CM ADDENDUM NO: One (1)

PROJECT: Housing Authority of the Cherokee Nation Phase II
Ganhili Addition – Jay, OK

To:	Bidding Documents Plan-Holders of Record Project File	Date:	April 25, 2024
		Addendum Number:	
		Architect's Project #:	20230079
		Project Name:	Ganohili Housing Development (Jay)
From:	BLUE RIVER ARCHITECTS, LLC 320 South Boston, Suite 103 Tulsa, Oklahoma 74103 Tel 918.877.9036	Professional Seal:

MARK	SERVICE	MANUFACTURER & MODEL	TANK VOLUME	WATTS	RECOVERY GPH @ 90 RISE	EFFICIENCY	VOLTAGE	FREQUENCY	PHASE	WEIGHT	NOTES
WH-1	HOT WATER	RHEEM XE50M06ST45U1	50.0 gal	4500	21	0.95	240 V	60 Hz	1	132 lb	1,3,4,5

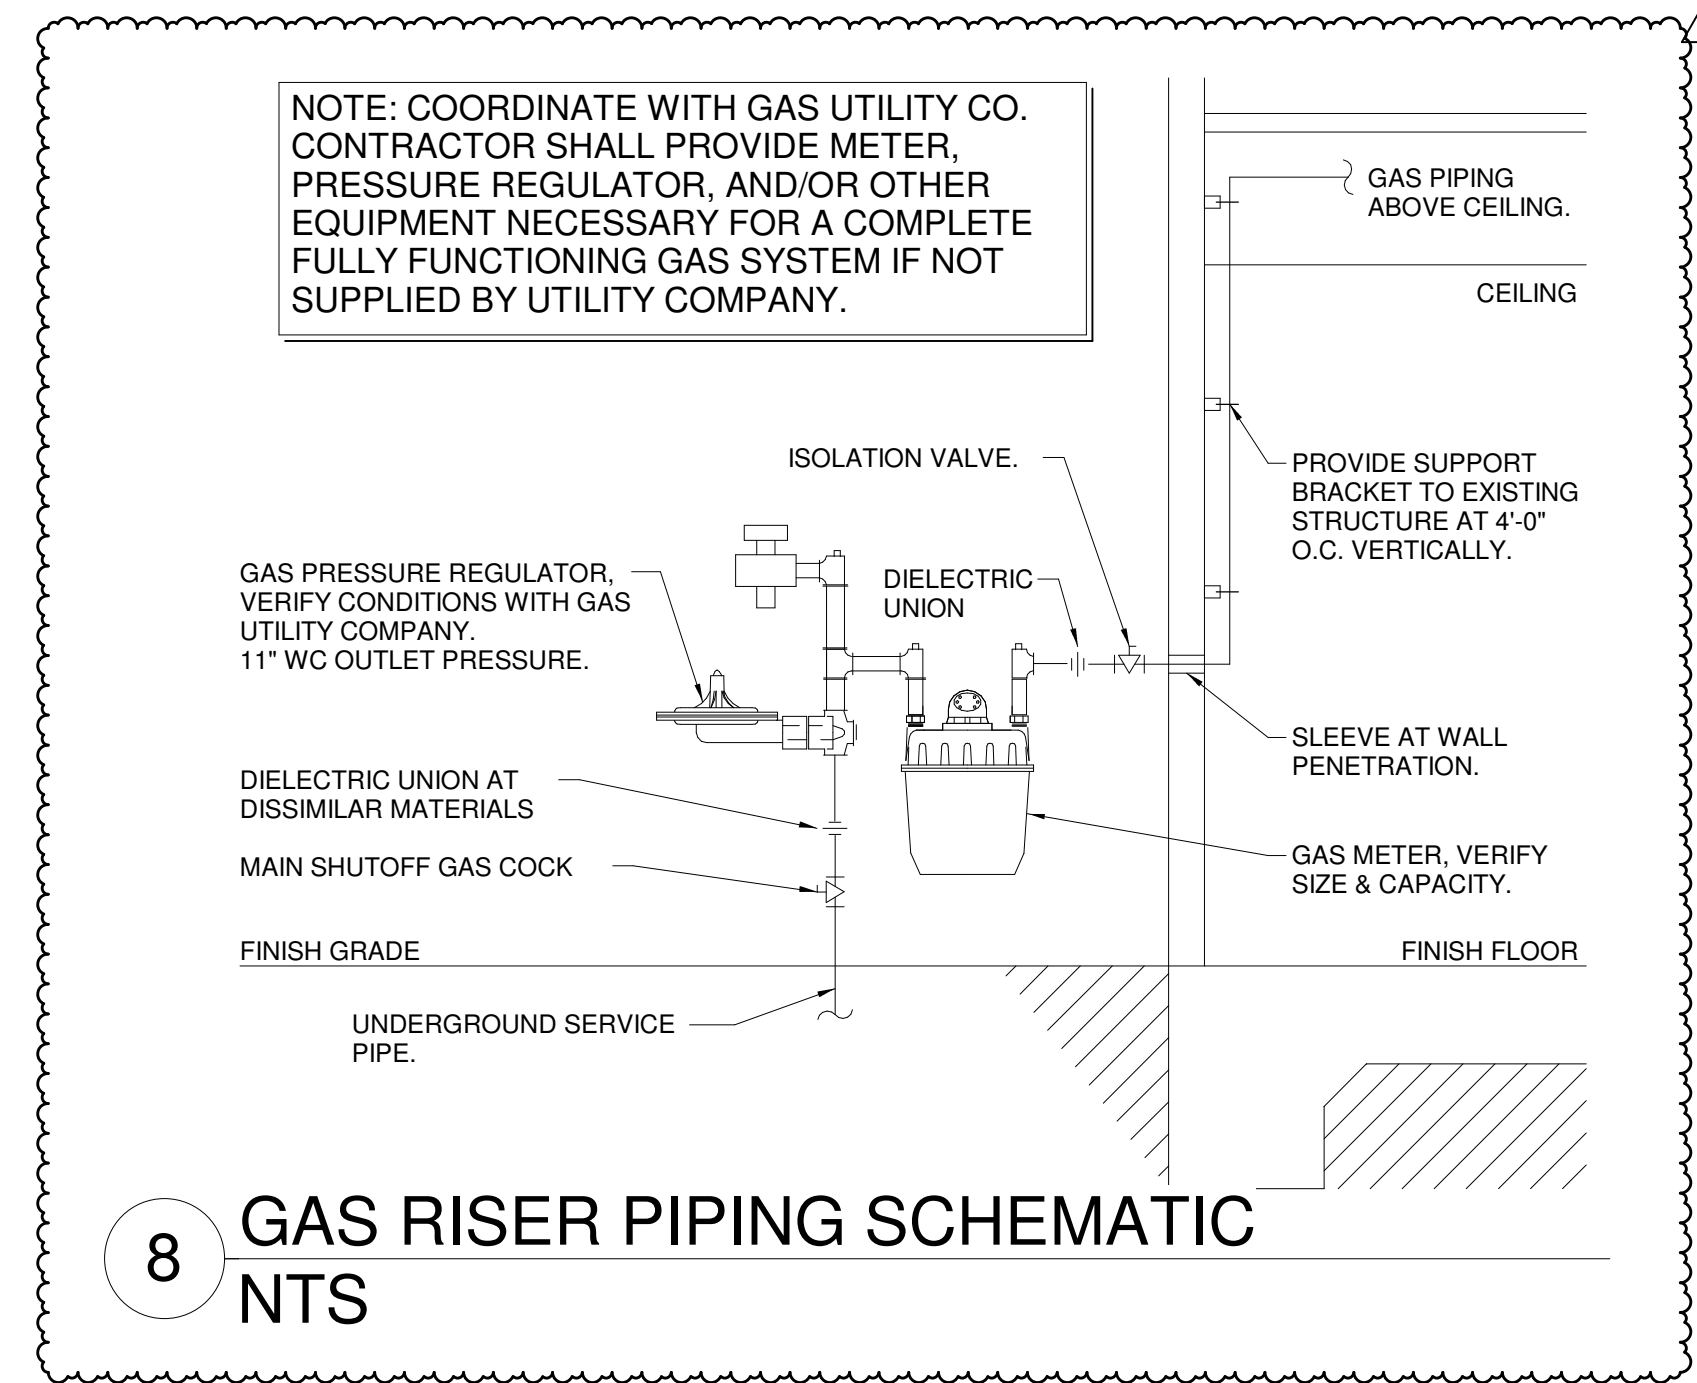
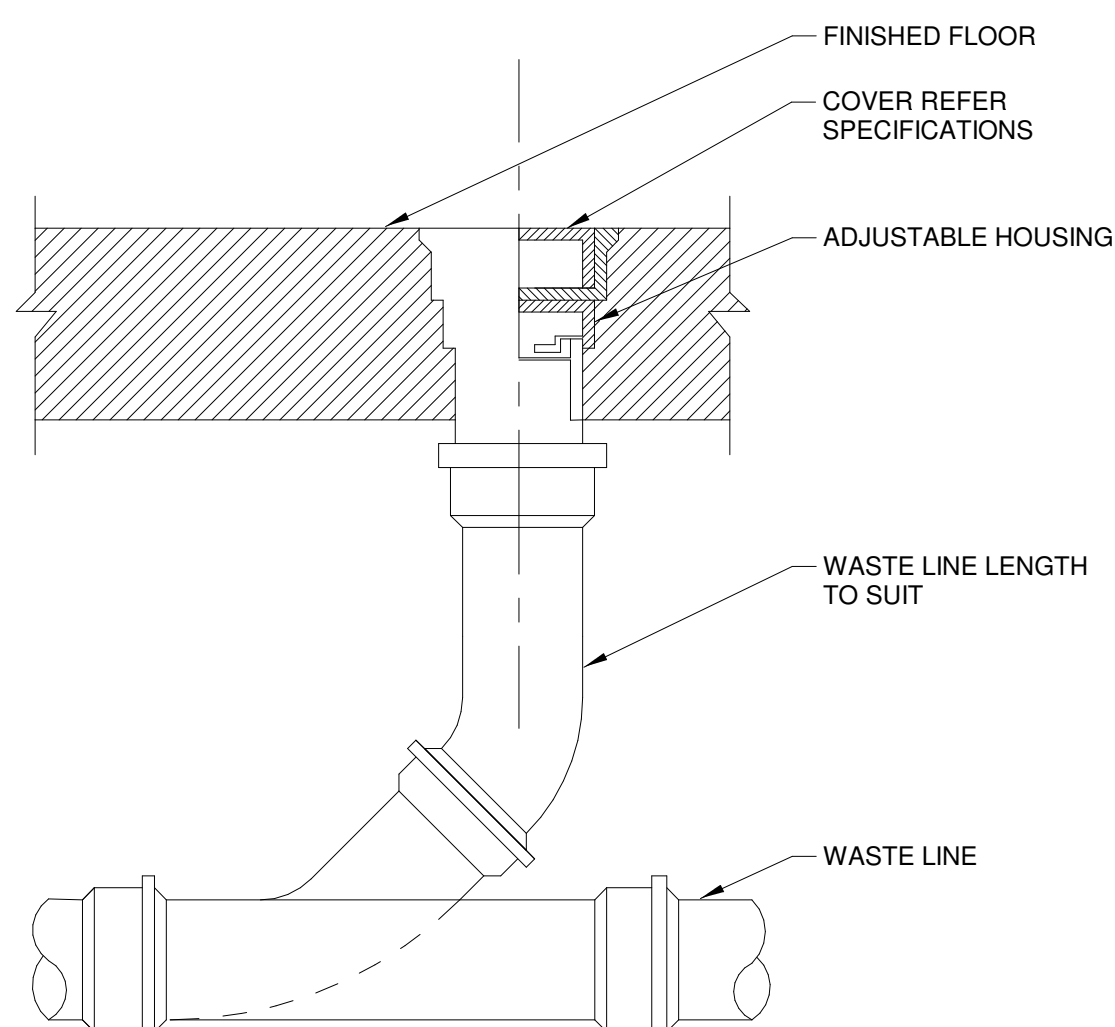
5. **Question:** The drawings do not reflect a gas line for the stove or dryer. i know there was discussion about the gas with the new energy requirement, but I thought the housing authority did want a drop for one of those.

Answer: See attached, revised sheets.
